GJS Plot F, Manchester

Non-material Amendment | 10.07.2024

Z1-SHP-A180-RP-XX-NMA02 | P01

Consented Scheme - F1-SHP-G100-EL-XX-B5D801 - P01

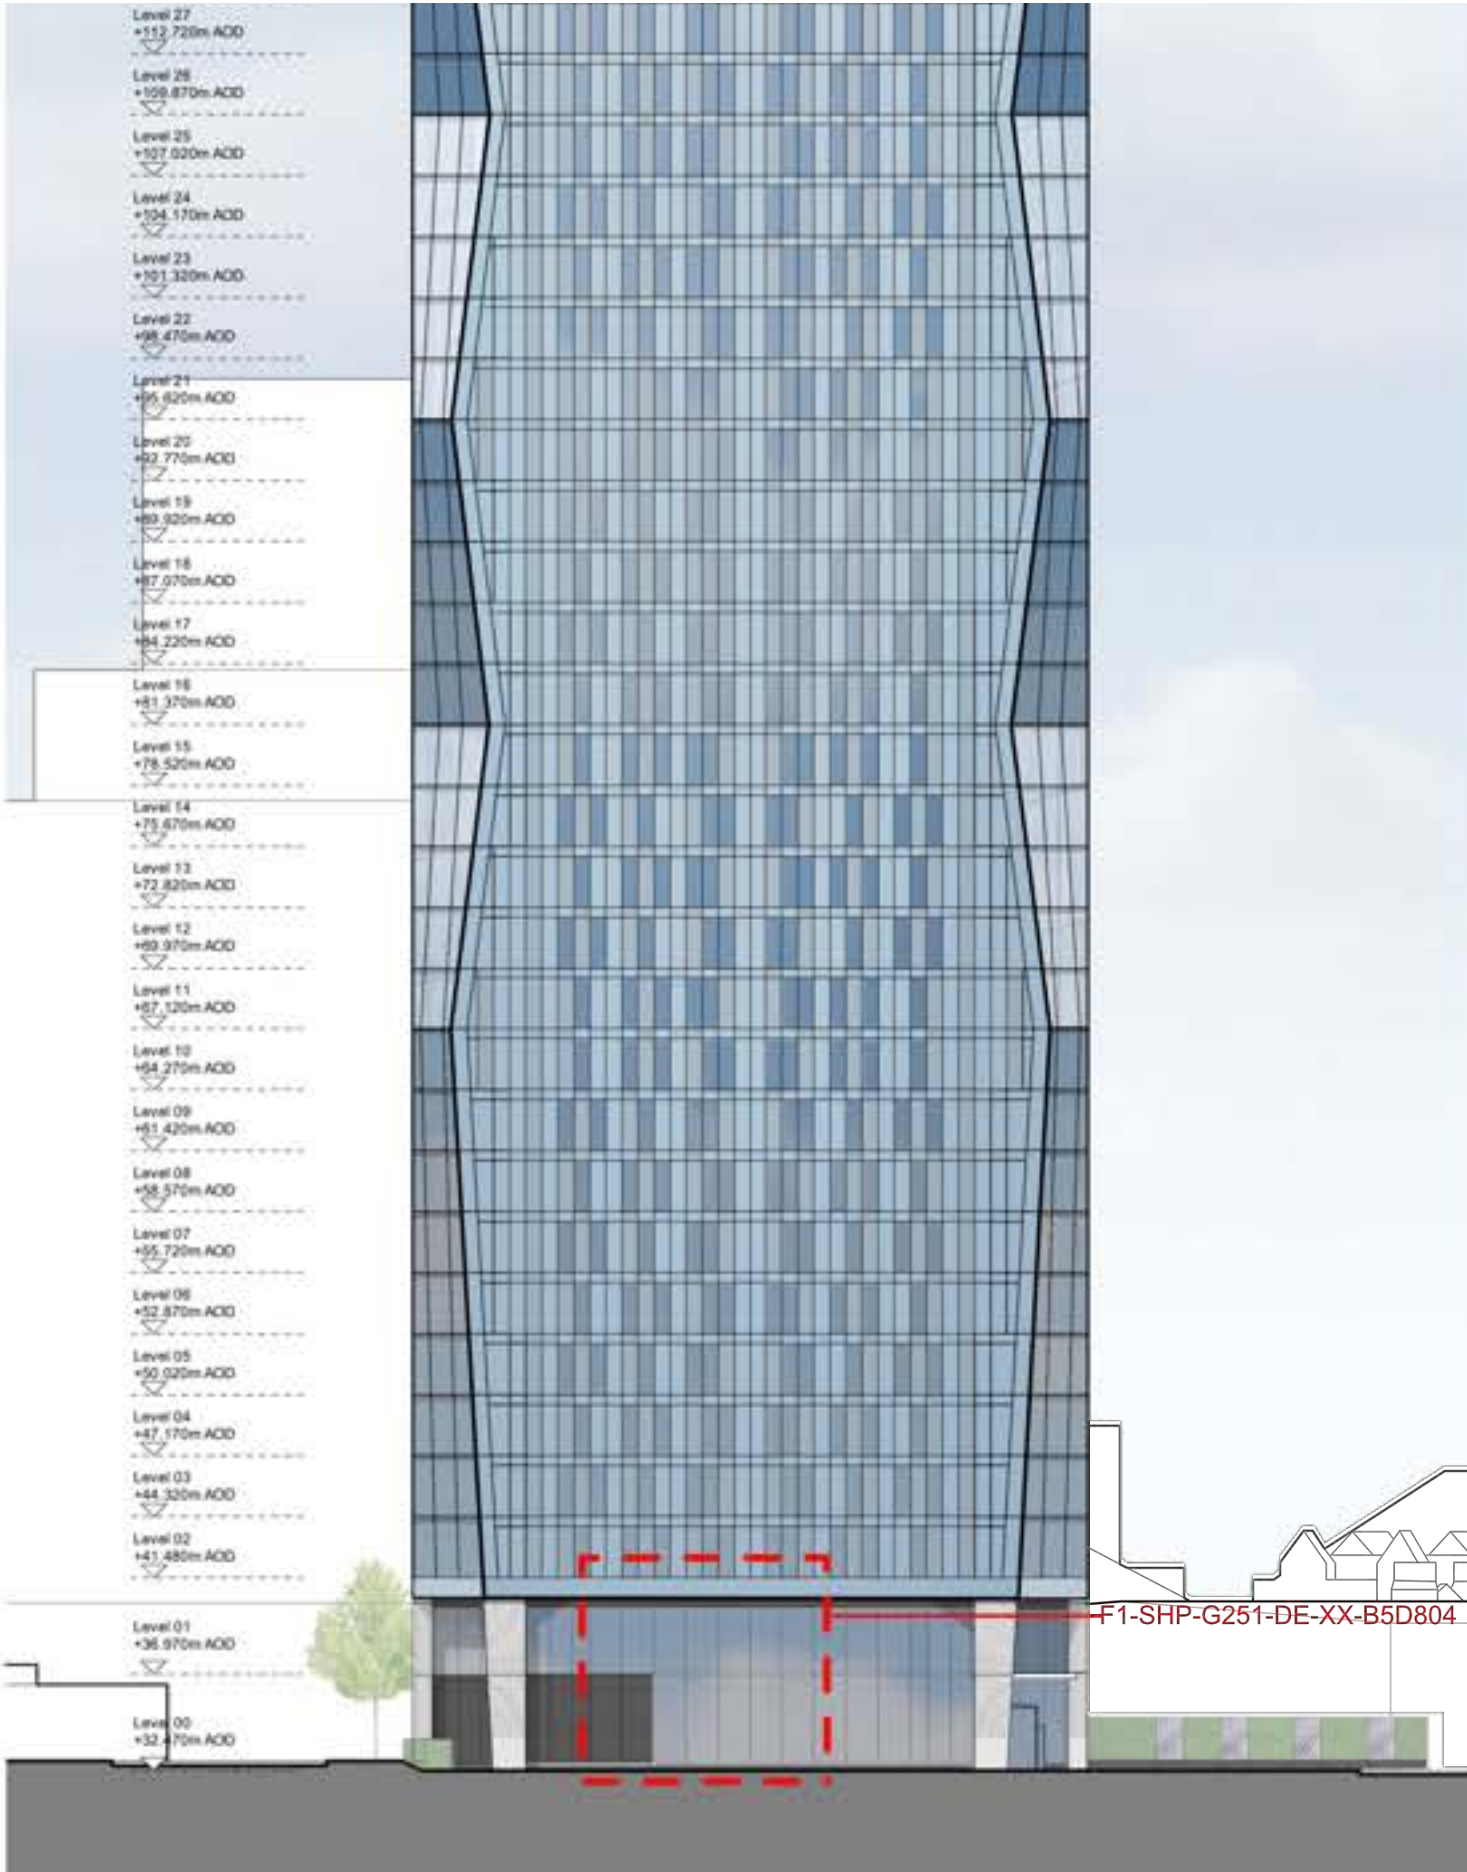
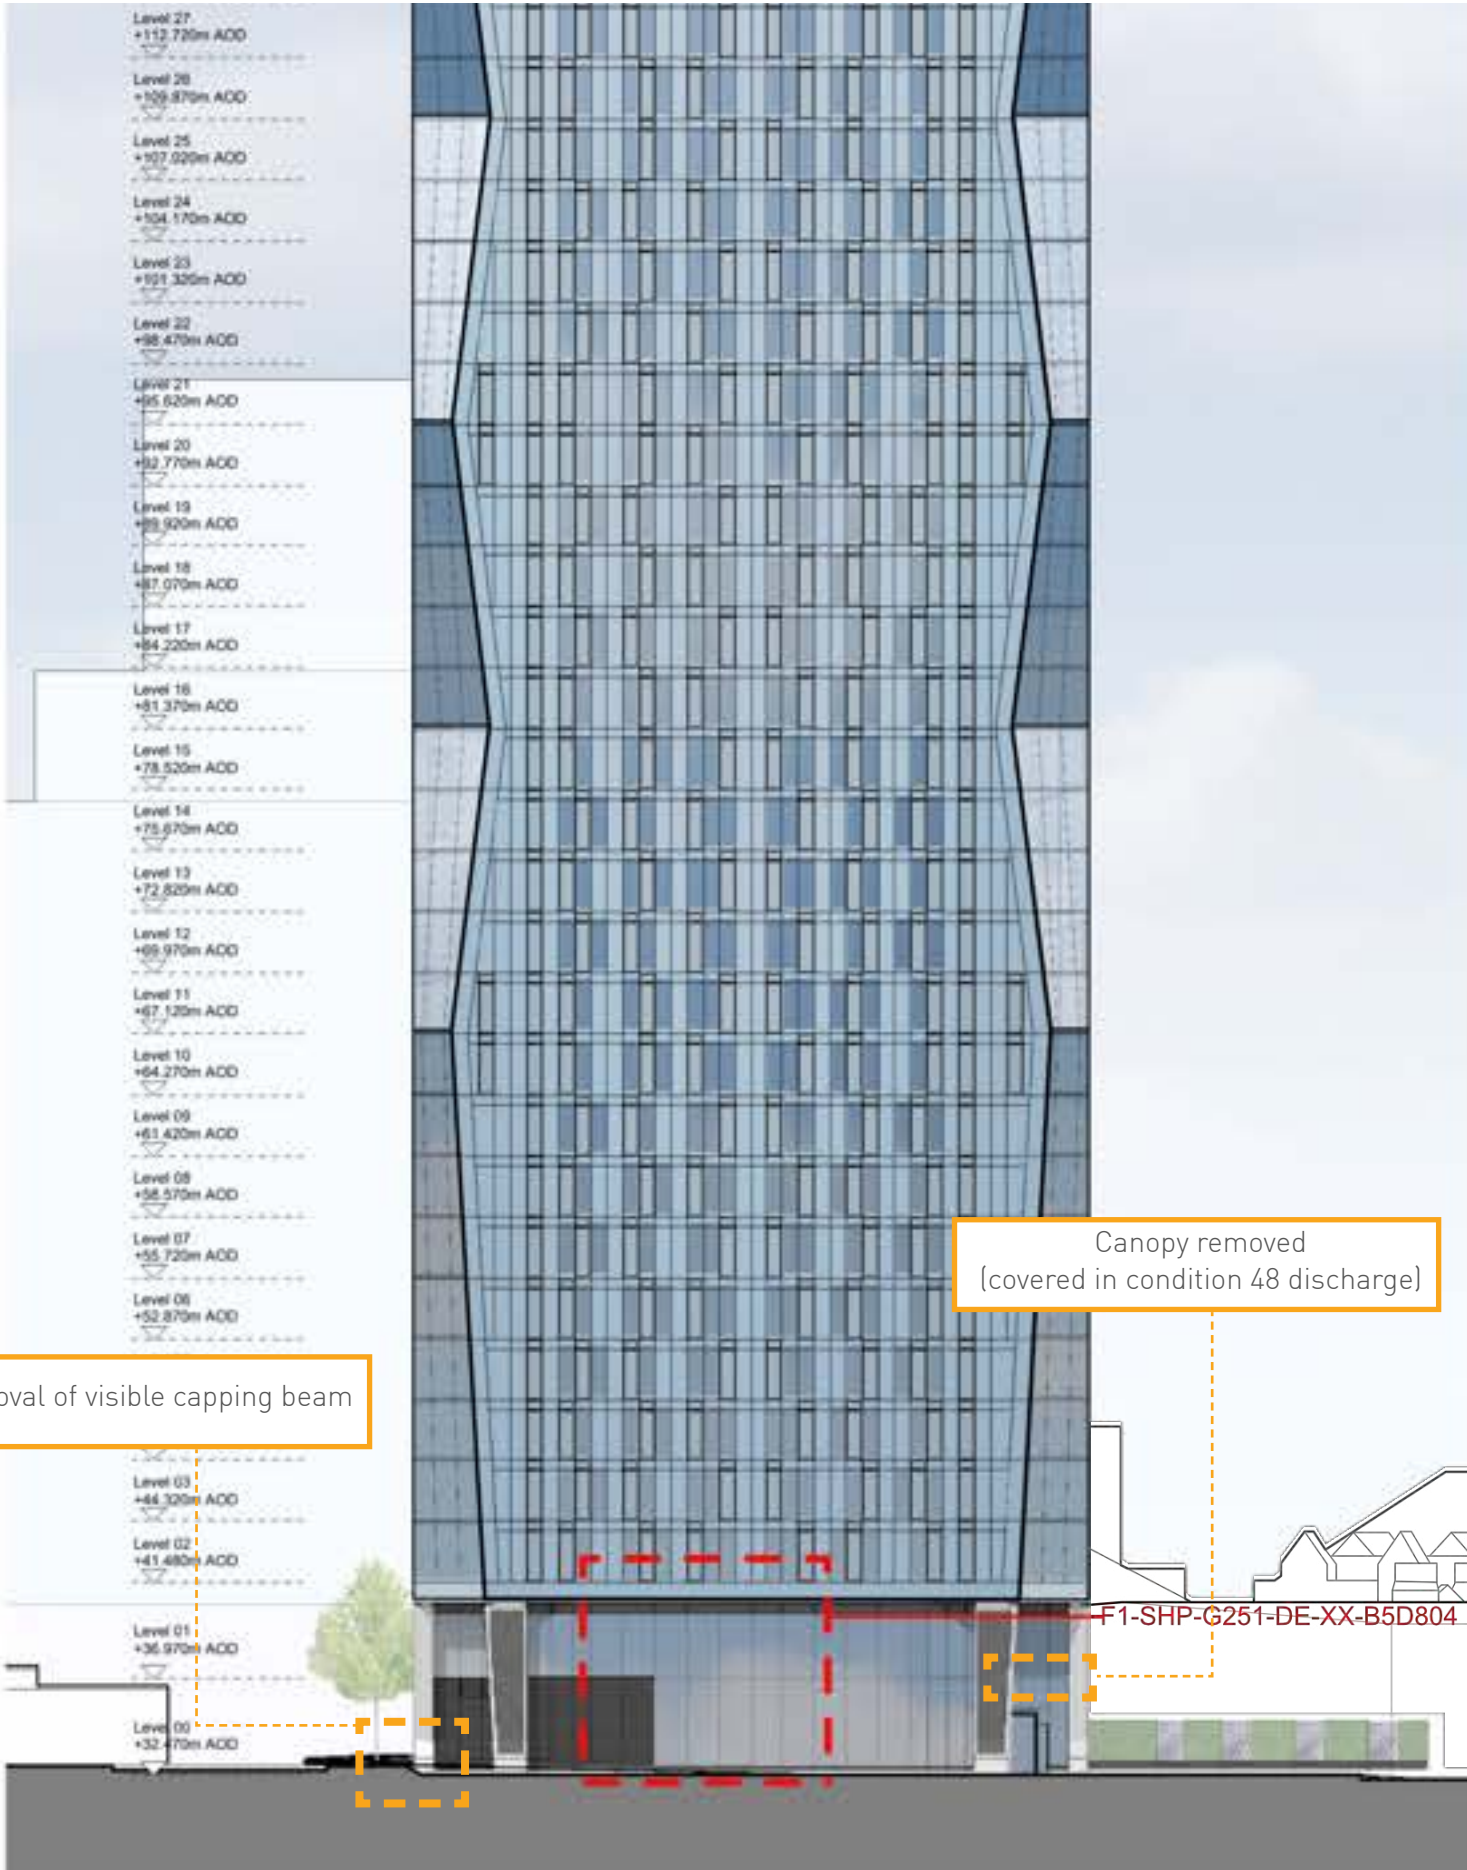
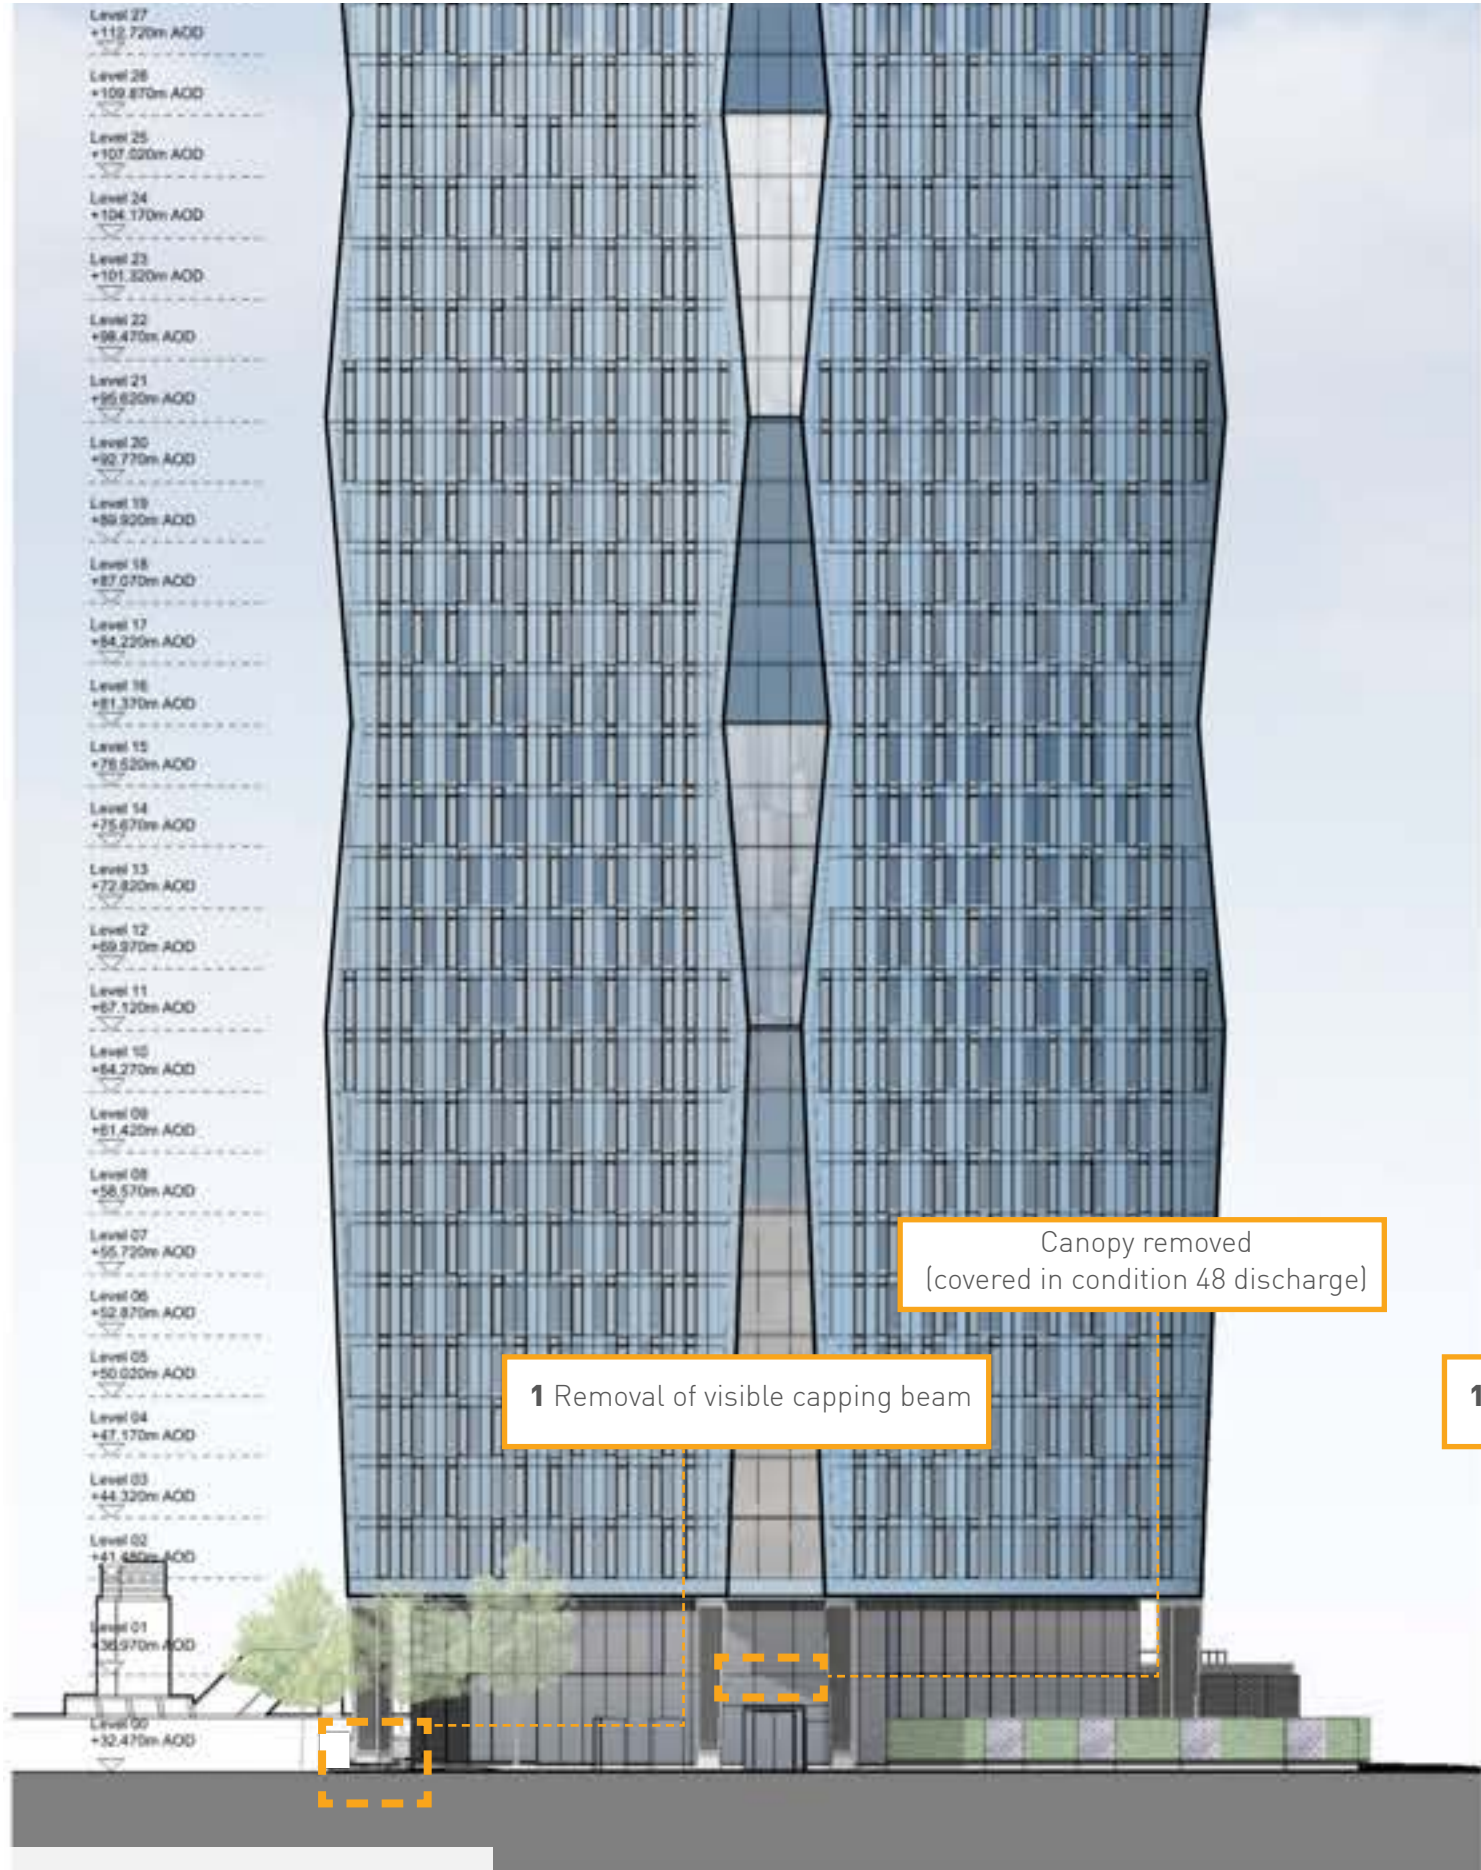
Tower F1 - Removal of visible capping beam along Great Jackson Street
At planning stage it was deemed necessary to keep the capping beam (top of the basement piled wall) above ground level, due to the proximity of the F1 capping beam to the pavement.

Through further structural design and refinement of temporary works, the design team have been able to lower the entirety of this structure so that it is not visible from street level, with the following benefits:
 - Feature columns are able to run full height - are not interrupted by the capping beam structure.
 - The public realm between the development and the pavement is more successful allowing for a more natural pedestrian circulation around the building without this imposition.
2.

1 Removal of visible capping beam
